001_Title Page

001_Title Page

Document Number:
PCB P/N:

Rev
005

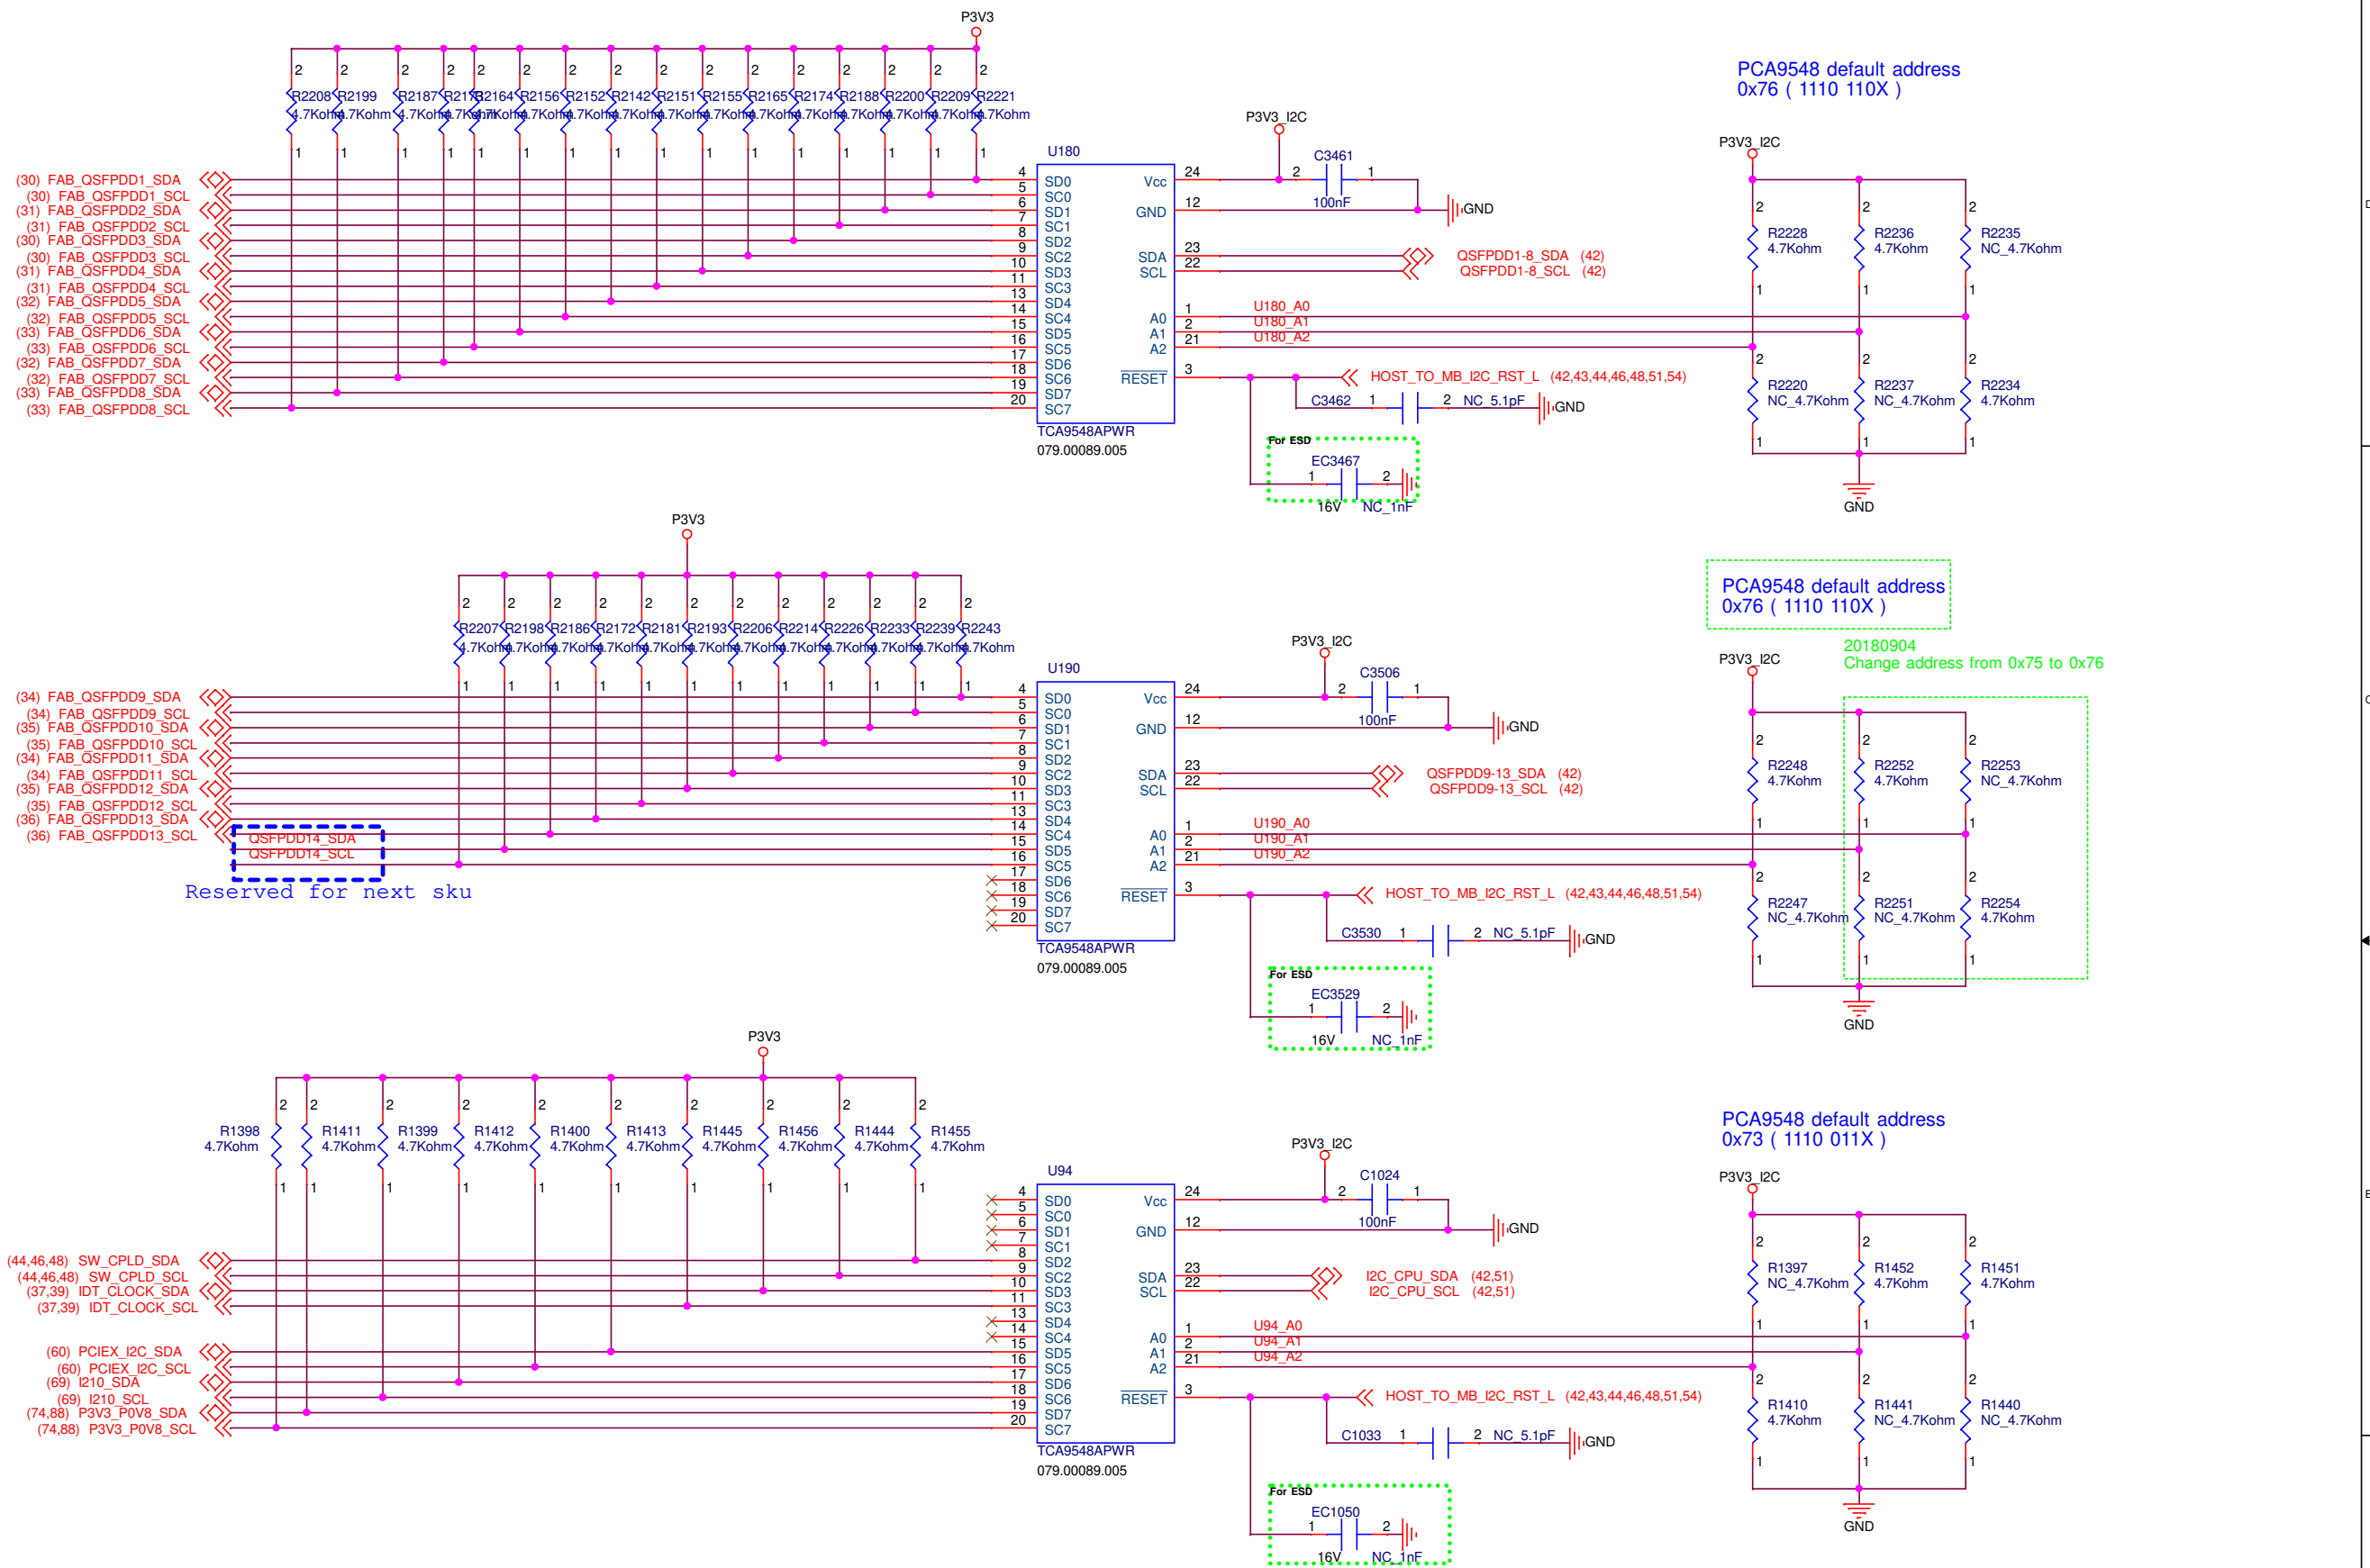
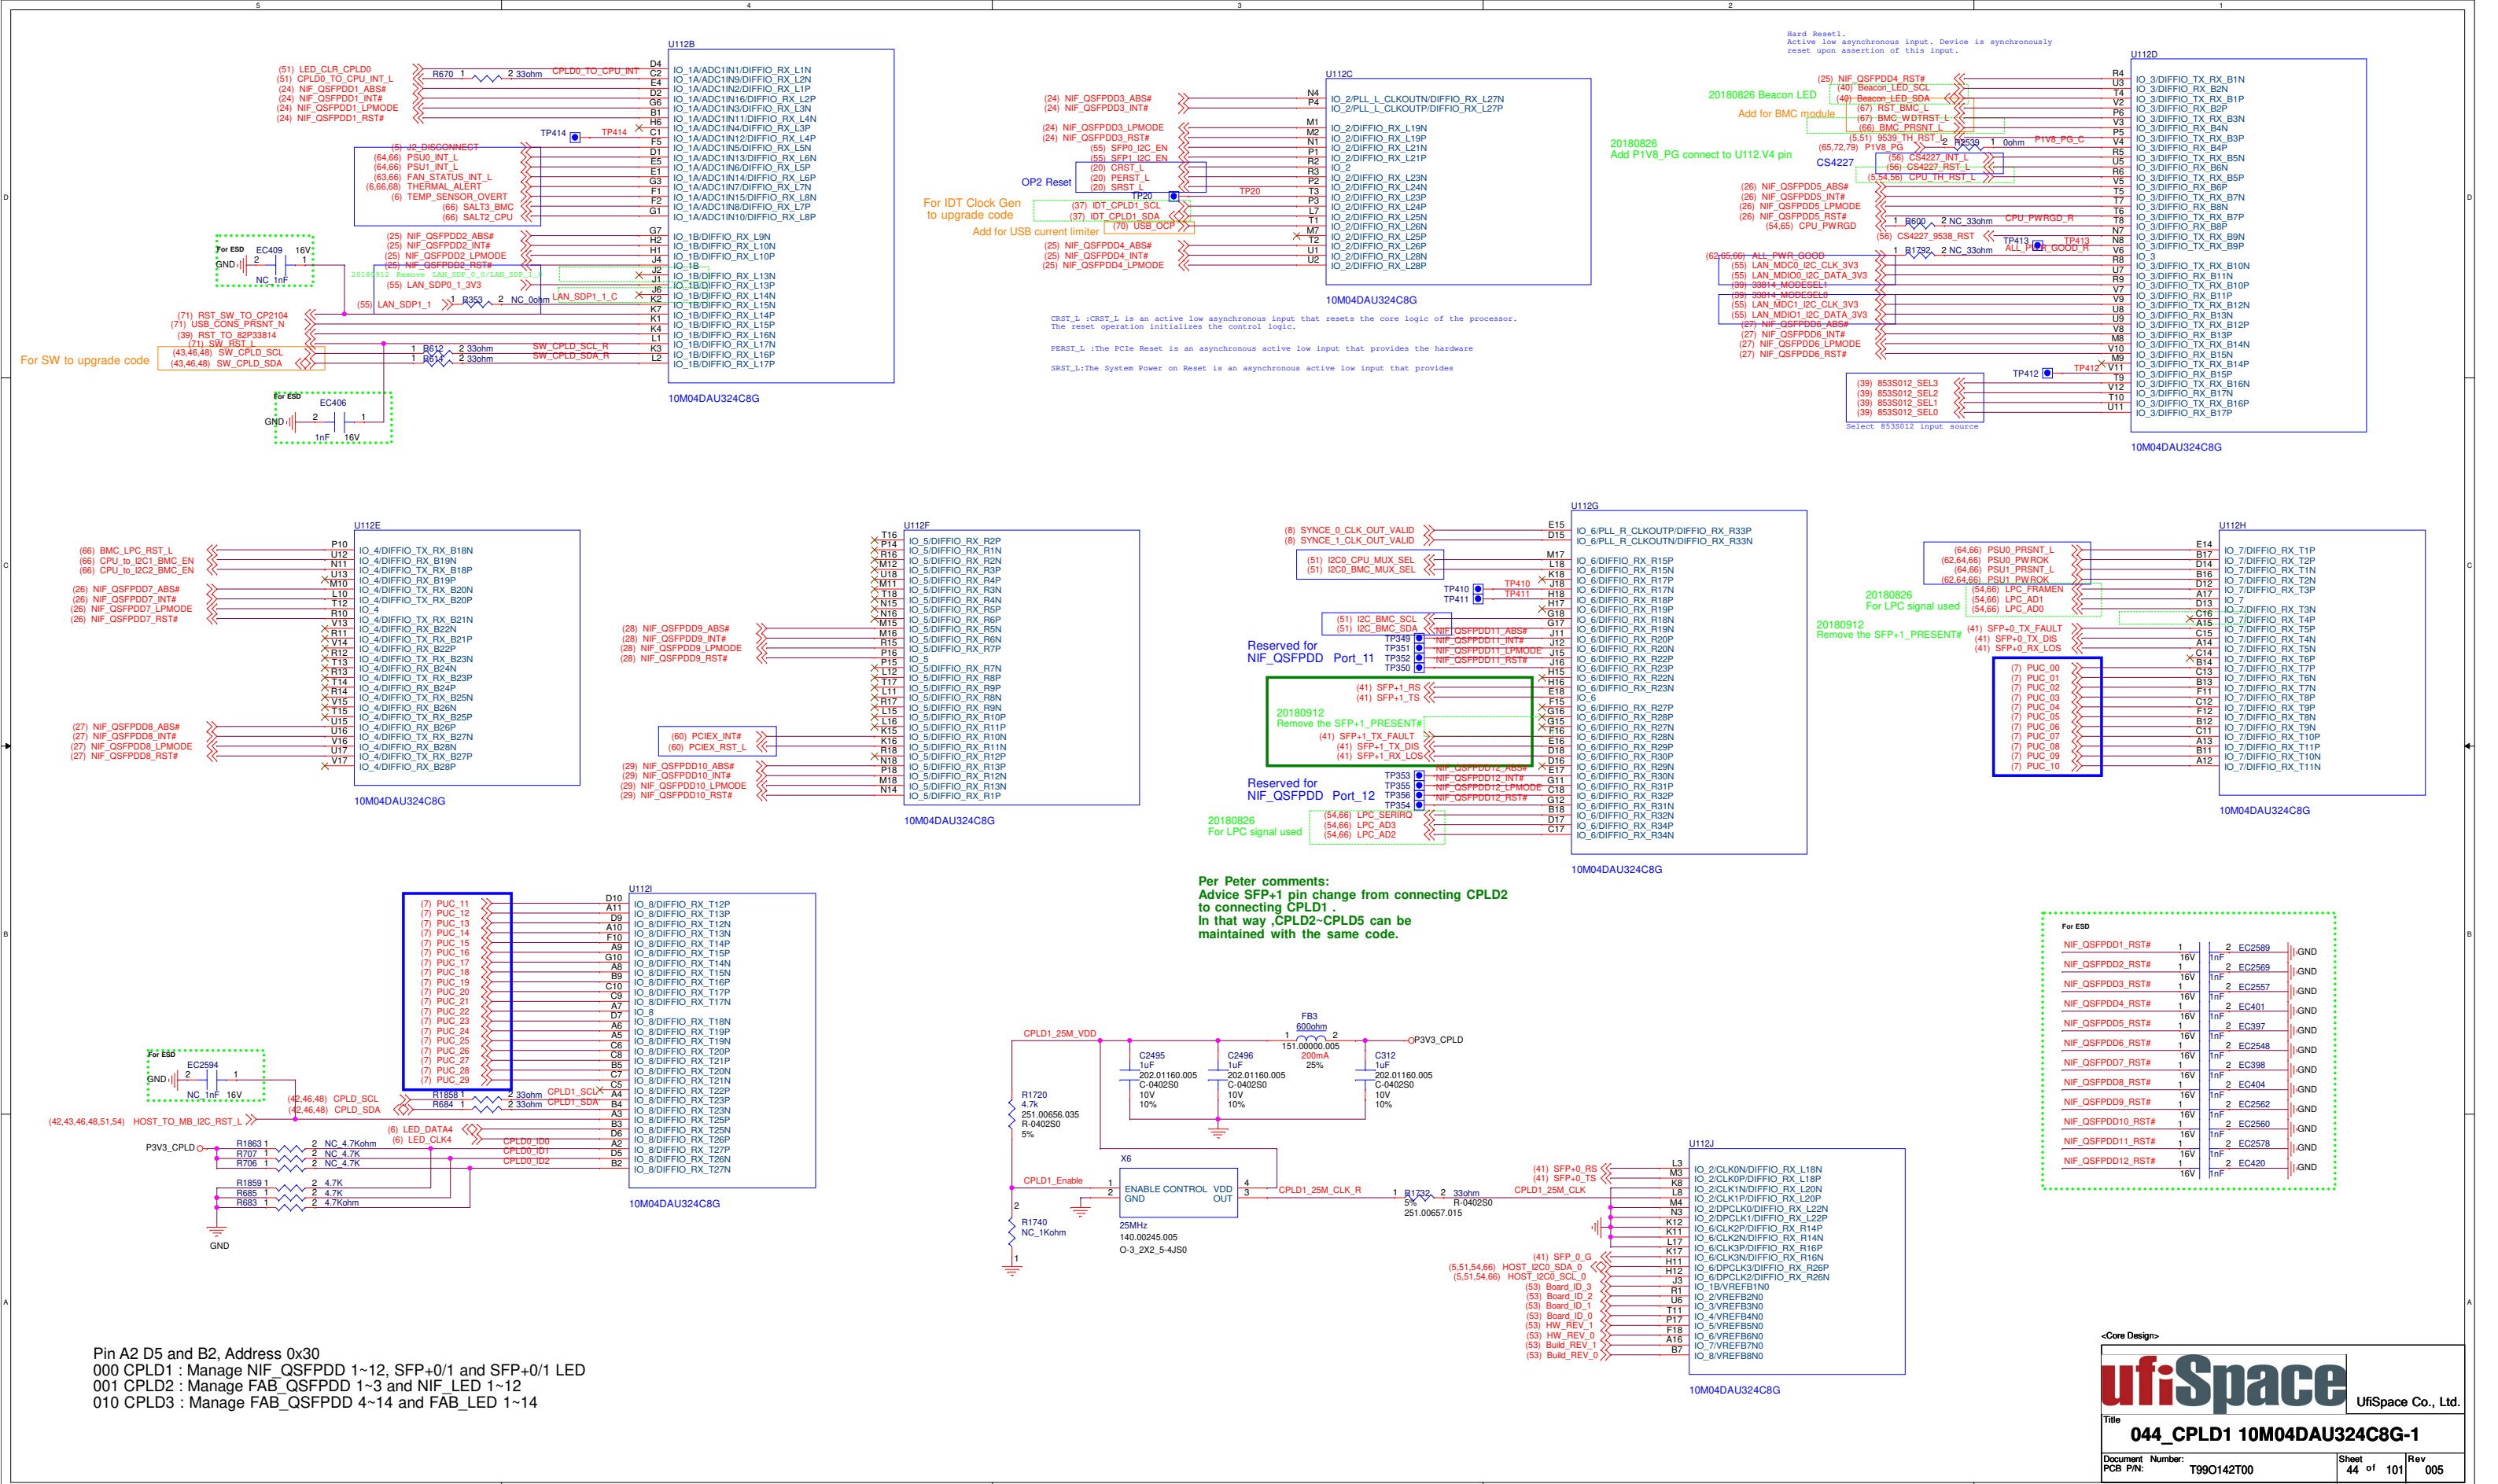
Changed all IO expander power source from P3V3 to P3V3_I2C.

20180904
Change address from 0x75 to 0x76

Title
051_I2C_SYSTEM

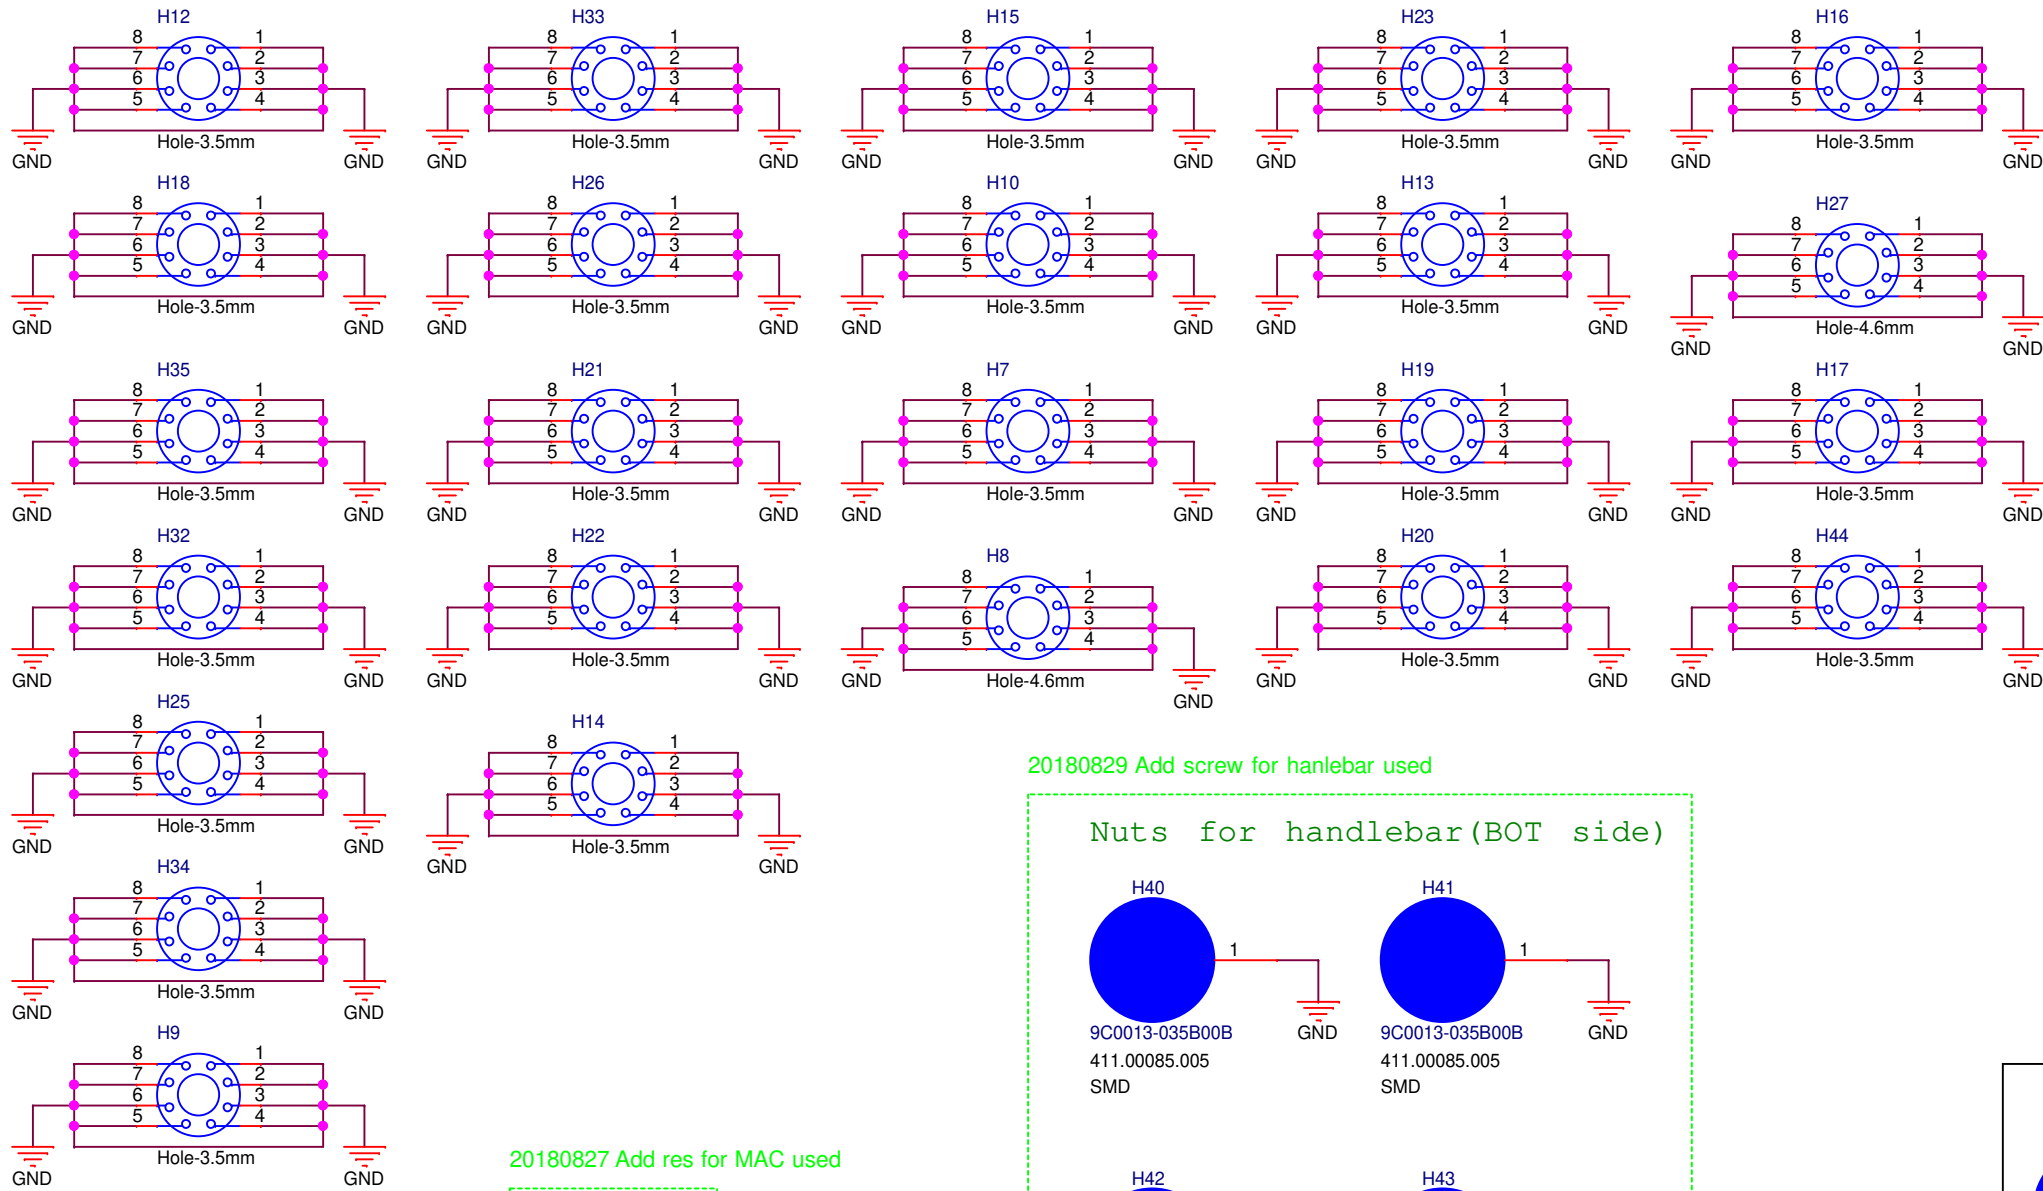
Add AND gate for CPLD0 and CPLD1 interrupt.
